# Access Compliance Report Public Rights-of-Way (RR Crossings)

Intersection ID: 12618	Main Street: E_5TH_ST	Location: N/A
ADA ID: CC3C8993546D	Overall Compliance: No	Severity Score: 0.0
<b>Codes/Mitigation Info/Possible Solution</b>	<b>Field Measurements/Component Compliance</b>

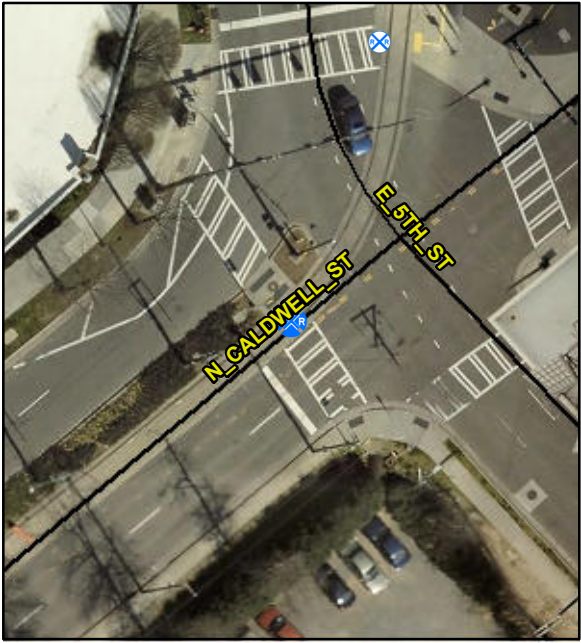
Surveyor Notes:  
**LIGHTRAIL IN STREET WITH MEDIAN REFUDGE ON ONE SIDE**

PROW/ADA:  
**R305.1.4, R305.2.5**

Compliance	Description	Data
Yes	DWS Provided?	Yes
Yes	DWS Contrast?	Yes
No	DWS Width (in)	No
Yes	DWS Length (in)	25.0
No	DWS Offset (in)	27.0
No	Pedestrian Gate?	No
N/A	DWS Outside Gate?	No
N/A	Rail Type?	LightRail
Yes	Flangeway Gap (in)	2.0
Yes	Sidewalk Width (in)	120.0

Possible Solutions:  
**Remove & Replace Detectable Warning System. Provide Pedestrian Gate.**
